PD Modification Application: PRS 24-1126
Zoning Hearing Master Date: N/A
BOCC Land Use Meeting Date: December 10, 2024

The subject Property is currently zoned PD 22-0864, which allows for an agricultural stand, residence, and harvest areas. The applicant is requesting to remove the transportation requirement for sidewalks and a crosswalk along the project frontage of West Bearss Avenue and Lake Magdalene Boulevard. The applicant contends that an agricultural stand is a temporary operation and that overrides the need for permanent improvements to the site.

Existing Approval(s):	Proposed Modification(s):
Requires sidewalks and a crosswalk along the project frontage of West Bearss Avenue and Lake Magdalene Boulevard.	Remove requirement for sidewalks and a crosswalk along the project frontage of West Bearss Avenue and Lake Magdalene Boulevard.

2.4.1 Proposed Site Plan (partial provided below for size and orientation purposes. See Section 7.2 for full site plan)

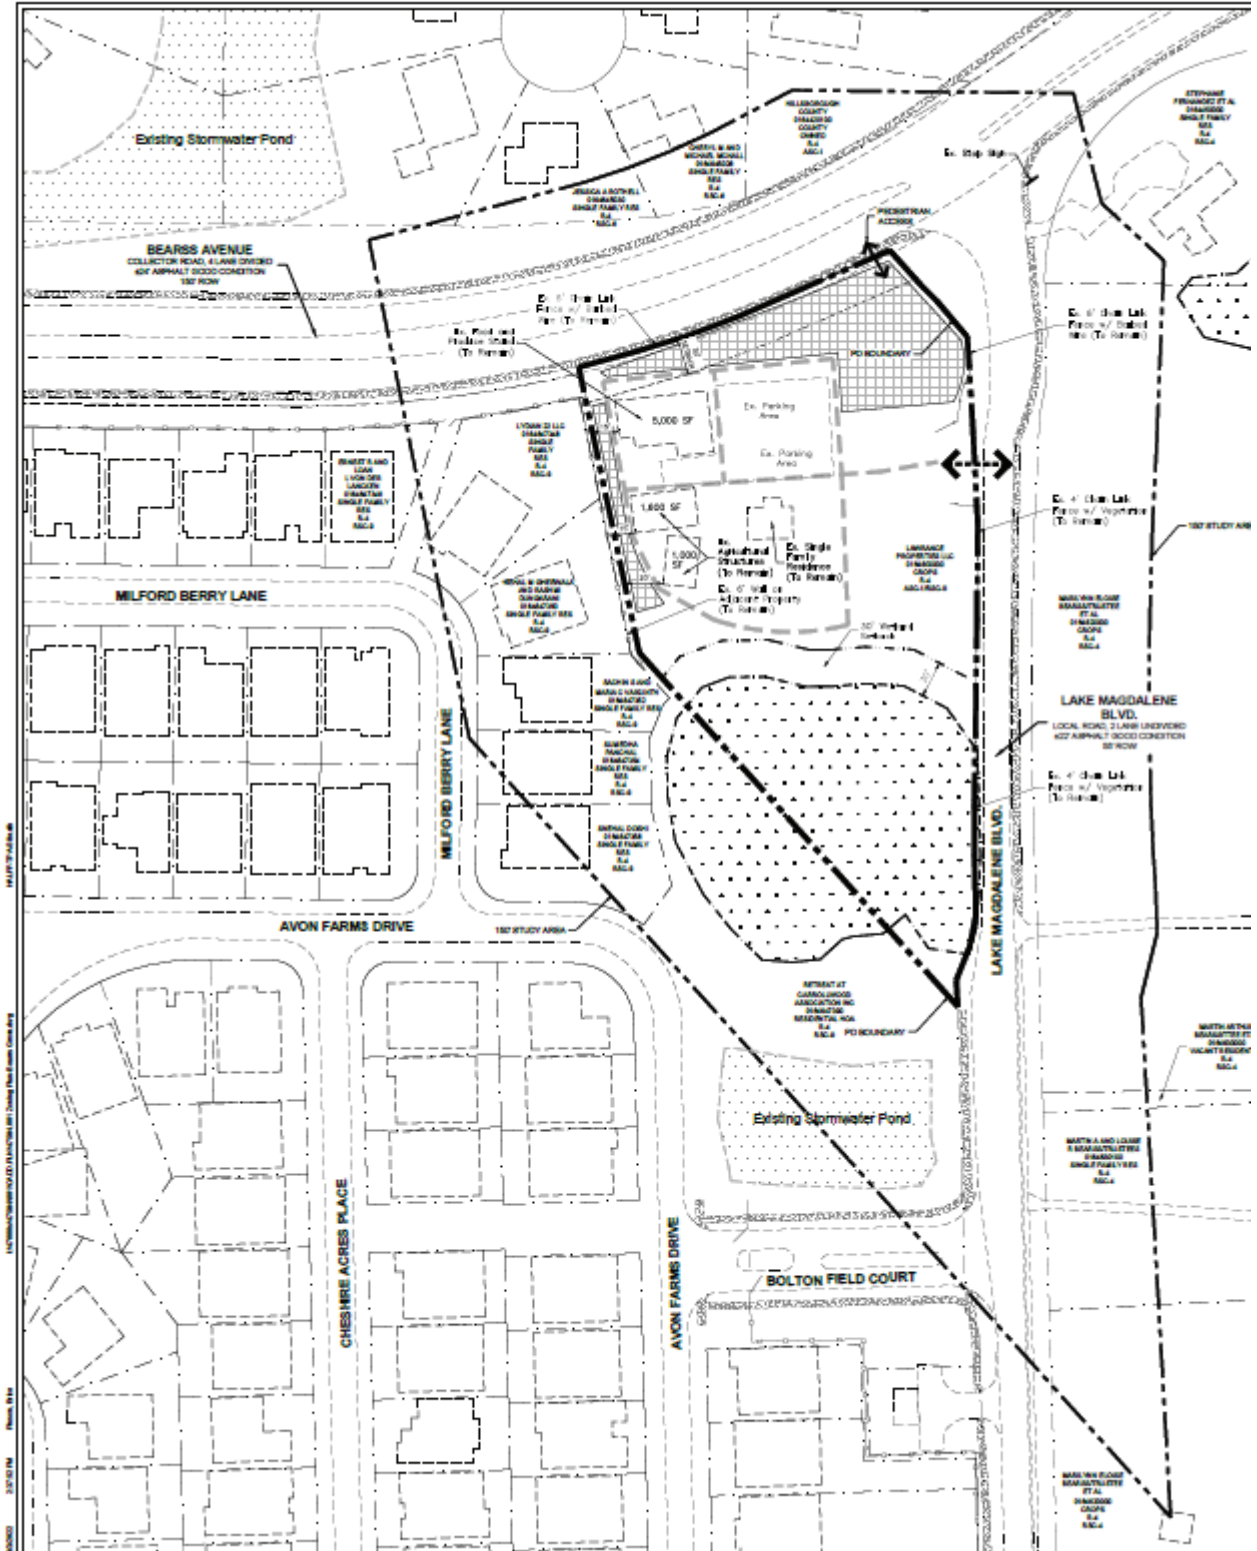
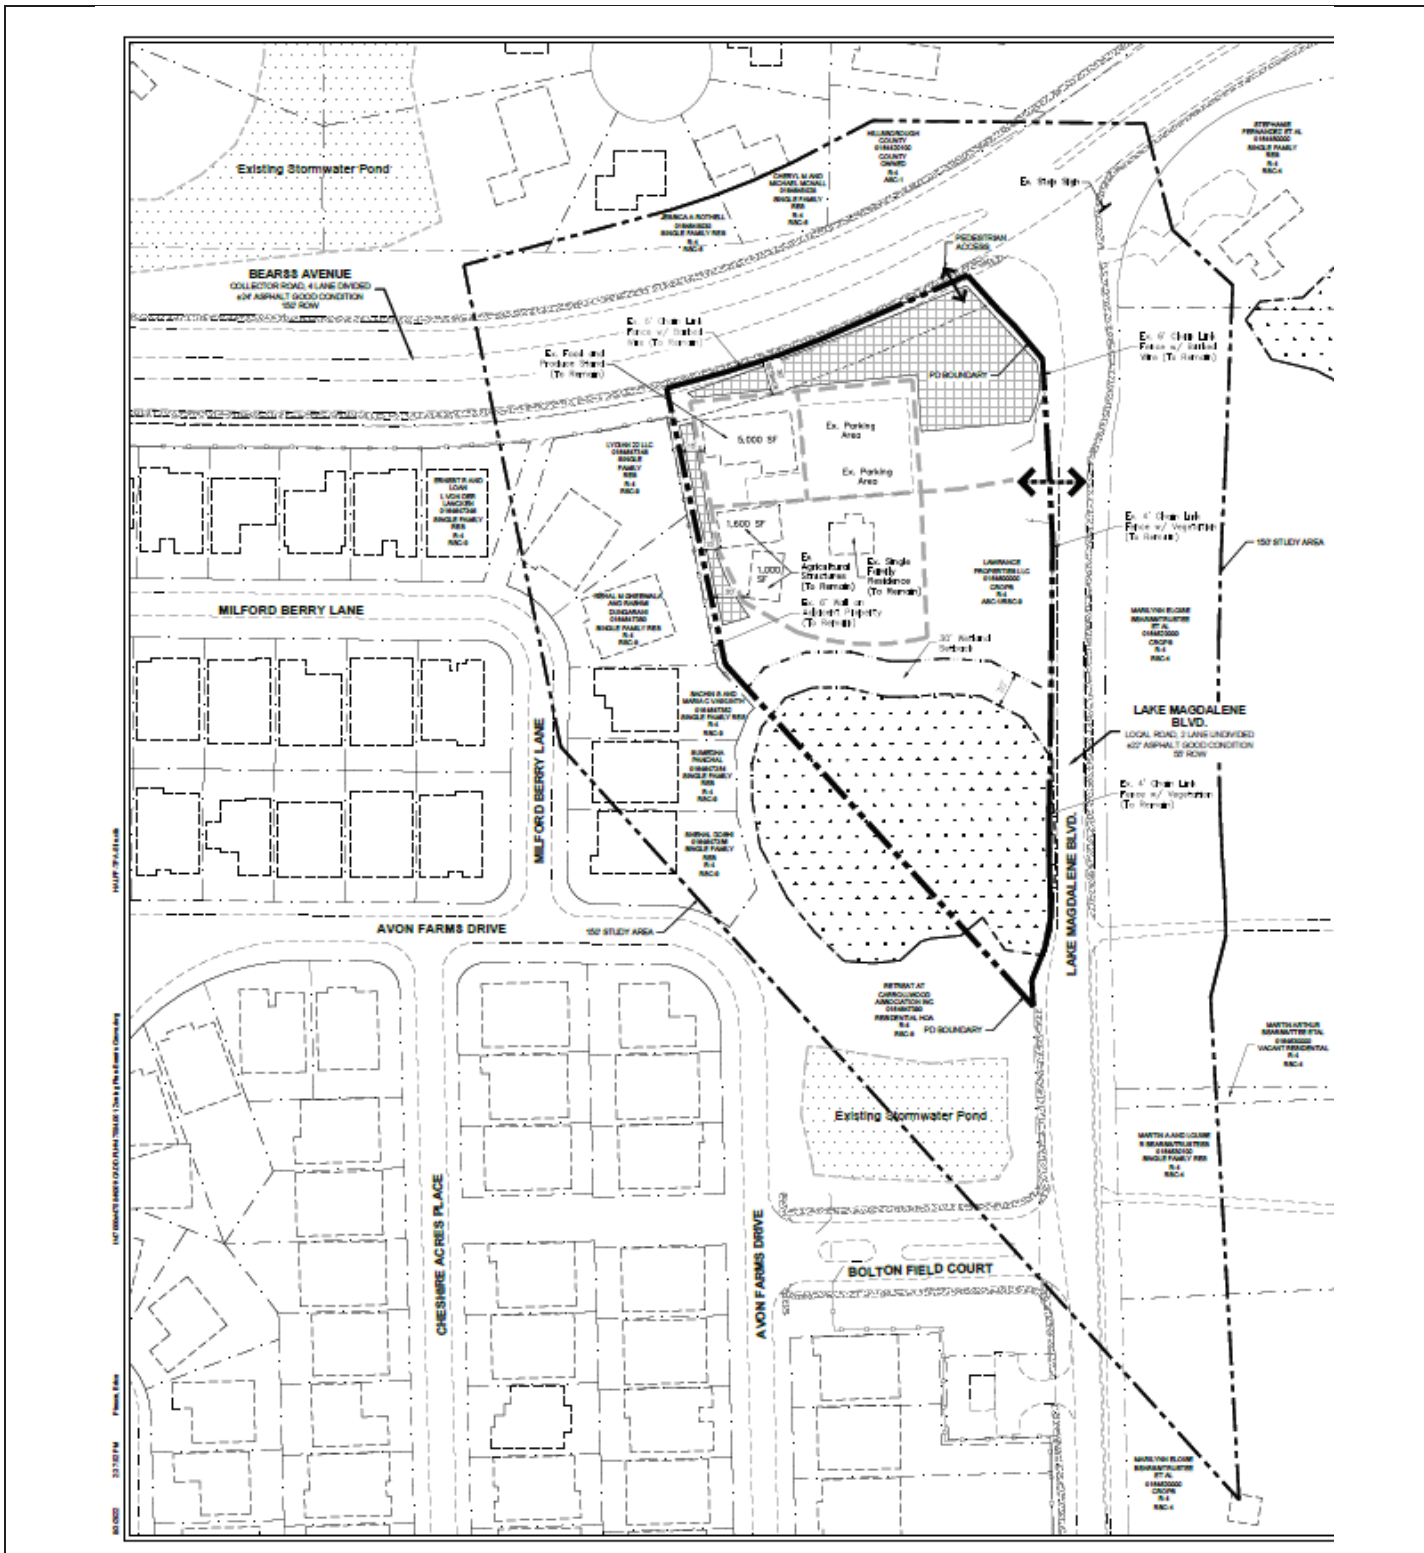
The applicant is proposing to remove the requirement for sidewalks and a crosswalk along the project frontage of West Bearss Avenue and Lake Magdalene Boulevard.

The transportation division reviewed the application and determined that the existing uses on the agriculture stand site constitute temporary uses. As such, sidewalk improvements required by Sec. 6.03.02. are not yet triggered.

The administrator reviewed the application and determined that the existing uses on the site constitute temporary uses. As such, sidewalk improvements required by Sec. 6.03.02. are not yet triggered. As such, staff supports the applicant’s requested removal of zoning condition 24.
